**CITY PLAN COMMISSION****THURSDAY, DECEMBER 5, 2024****FILE NUMBER:** S245-033**SENIOR PLANNER:** Sharmila Shrestha**LOCATION:** bounded by Berkshire Lane, Westchester Drive, Luther Lane, and Douglas Avenue.**DATE FILED:** November 7, 2024**ZONING:** PD 314, (Tract 3, Subdistrict A)**PD LINK:** <https://dallascityhall.com/departments/city-attorney/Articles/PDF/Article%20314.pdf>**CITY COUNCIL DISTRICT:** 13**SIZE OF REQUEST:** 4.5996-acres**APPLICANT/OWNER:** Alpine Douglass, LLC, Alpine Preston Center, LLC**REQUEST:** An application to replat a 4.5996-acre tract of land containing all of Lot 6A and a tract of land in City Block 5632, and the abandoned portion of 15 feet alley to create one lot on property bounded by Berkshire Lane, Westchester Drive, Luther Lane, and Douglas Avenue.**SUBDIVISION HISTORY:**

**PRELIMINARY PLAT**  
**LOT 6A, BLOCK 5621**  
**PRESTON CENTER ADDITION**  
 ALL OF CITY BLOCK 5621  
 ANDREW J. MANWELL ARCHITECT  
 CITY OF DALLAS, DALLAS COUNTY, TEXAS  
 PLAT NO. 008-100  
 PLANNING AND ORDINANCE NO. \_\_\_\_\_

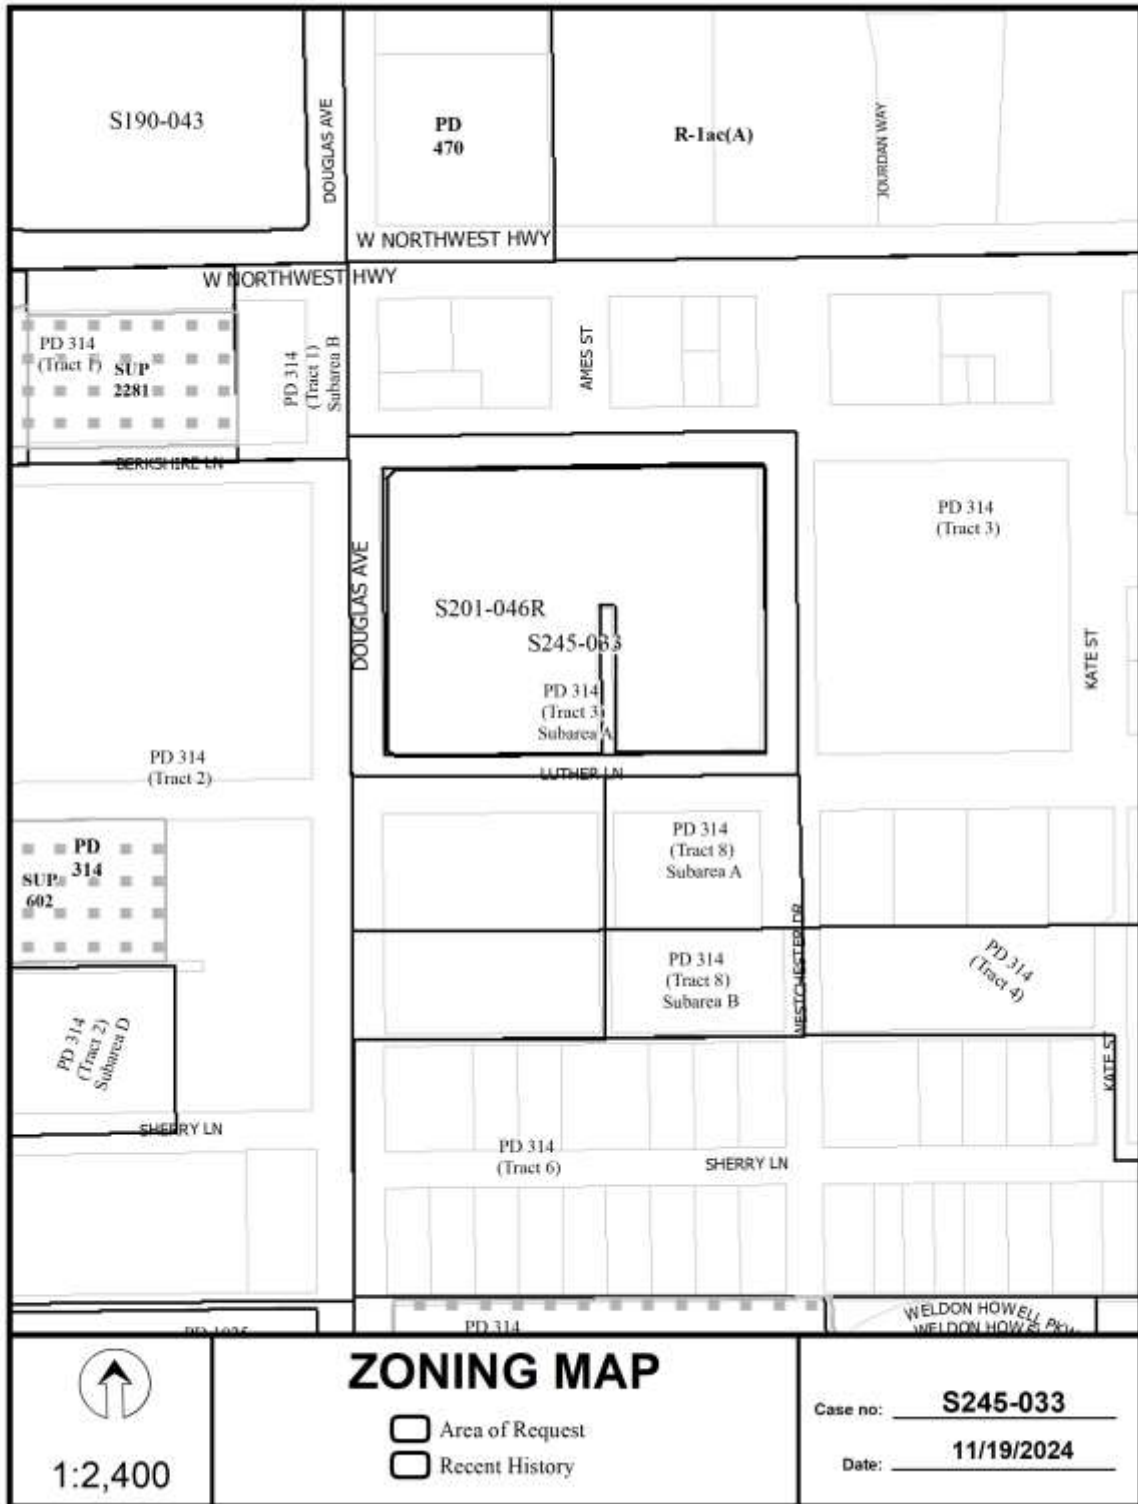
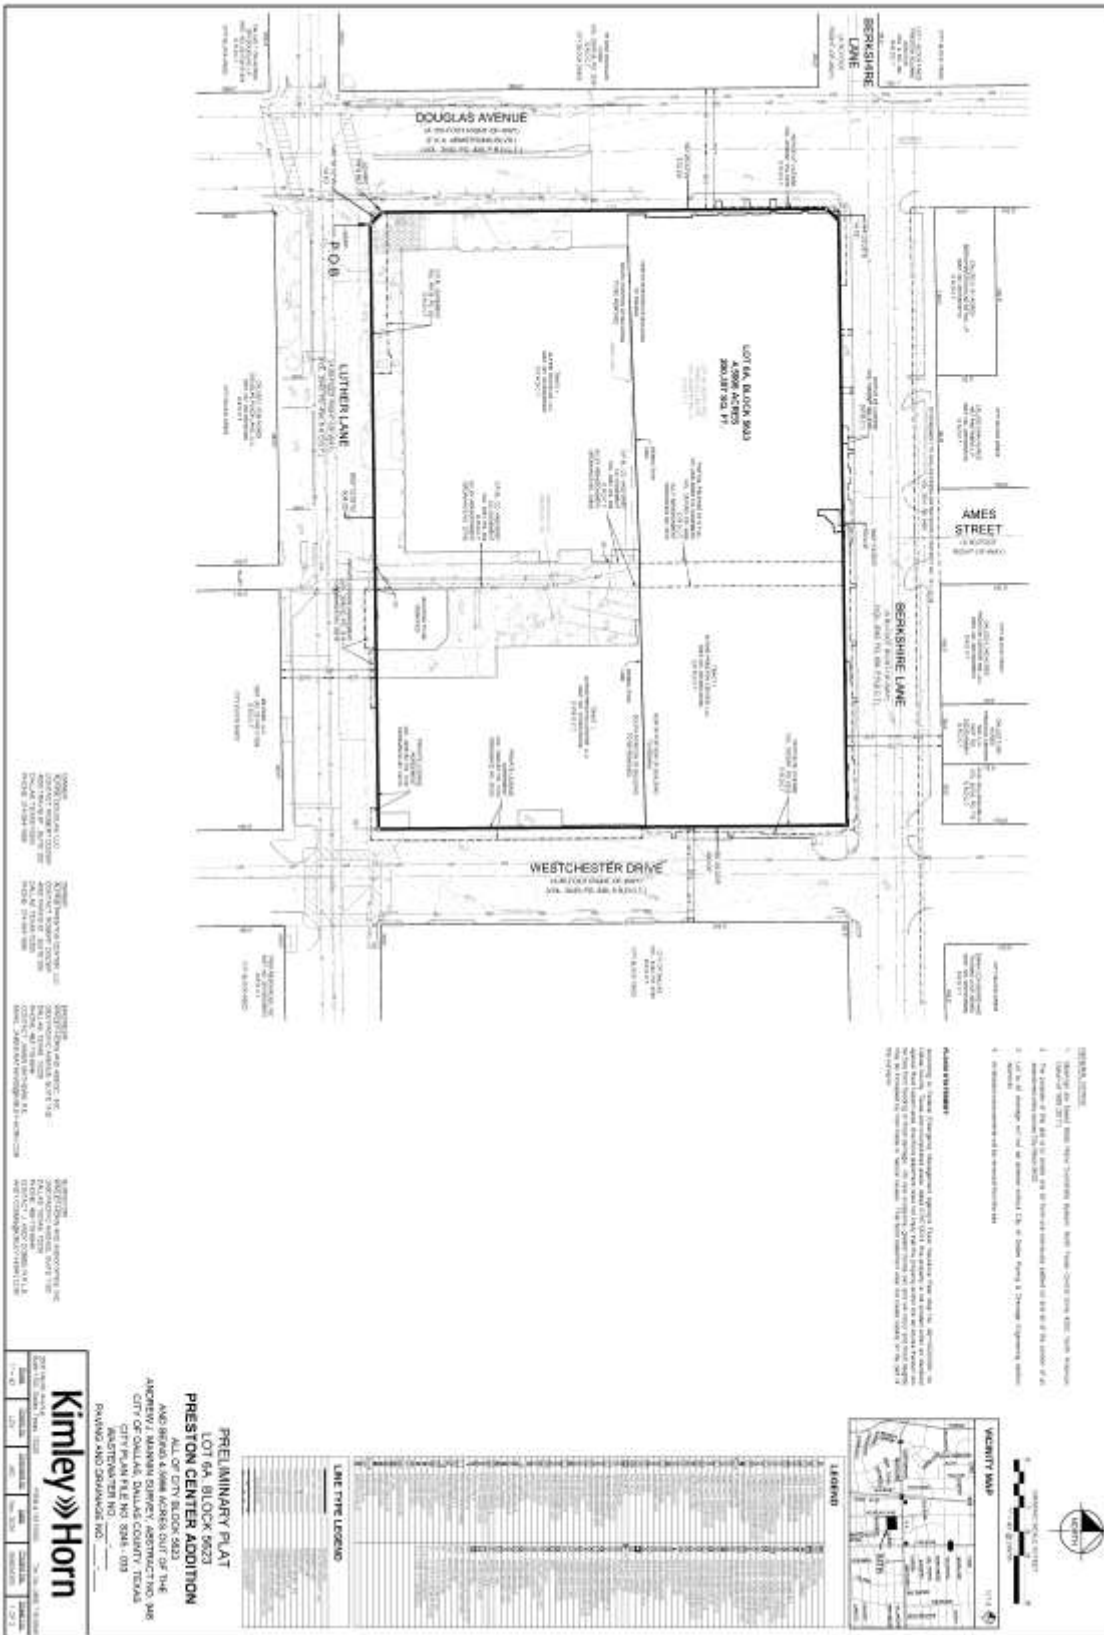
15. On the final plat, dedicate a minimum 20-foot by 20-foot corner clip (via fee simple or street easement) at the intersection of Douglas Avenue and Luther Lane. Section 51A 8.602(d)(1)
16. On the final plat, dedicate a minimum 20-foot by 20-foot corner clip (via fee simple or street easement) at the intersection of Douglas Avenue and Berkshire Lane. Section 51A 8.602(d)(1)
17. On the final plat, dedicate a minimum 5-foot by 5-foot corner clip (via fee simple or street easement) at the intersection of Berkshire Lane and Westchester Drive. Section 51A 8.602(d)(1)
18. On the final plat, dedicate a minimum 5-foot by 5-foot corner clip (via fee simple or street easement) at the intersection of Luther Lane and Westchester Drive. Section 51A 8.602(d)(1)

20. Prior to final plat, submit a completed final plat checklist and all supporting documents.
21. On the final plat, list utility easements as retained within street abandonments when stated in the abandonment ordinance or follow the City of Dallas standard affidavit requirements.
22. On the final plat, chose a new or different plat name.
23. Prior to final plat, clarify existing 6-inch sanitary sewer line under building to remain.

24. Engineer must furnish plans for water and sanitary sewer. Developer must furnish a contract for water and sanitary sewer. Sections 49-60(g)(1) and (2) and 49-62(b), (c), and (f).
25. Additional design information is required for assessment. Site plan must be submitted showing proposed development, building finished floor elevation, development, existing mains – including downstream manhole, and proposed water and wastewater service locations. Submit water/wastewater engineering plans to 320 E. Jefferson Blvd., Room 200, Attention: Water and Wastewater Engineering.
26. Water and wastewater main improvements are required by Private Development Contract. Submit water/wastewater engineering plans to 320 E. Jefferson Blvd., Room 200, Attention: Water and Wastewater Engineering.

27. Comply with Street Design Manual Section 4.3.3.2(D) and Section 4.4.2.1 regarding required minimum corner clips at intersections.
28. On the final plat, show the alley abandonment on the plat as follows: Abandonment authorized by Ordinance No. \_\_\_\_\_, recorded as Inst. Nos. (Cert. ORD No. \_\_\_\_\_, QCD No. \_\_\_\_\_). Utility Easements retained

29. Prior to final plat, contact Real Estate to discuss Notice of License regarding encroachments in R.O.W. located on Westchester, Luther Lane, and Berkshire Lane. Please show Private License Agreement Vol. 182 and Pg. 1316 on plat as follows: License Agreement authorized by Ordinance number \_\_\_\_\_ recorded as Inst. No. or Volume \_\_\_\_\_ and Page \_\_\_\_\_.

30. On the final plat, change “Berkshire Lane” to “Berkshire Lane (AKA Berkshire Street)”. Section 51A-8.403(a)(1)(A)(xii).
31. On the final plat, identify the property as Lot 6B in City Block 5623.
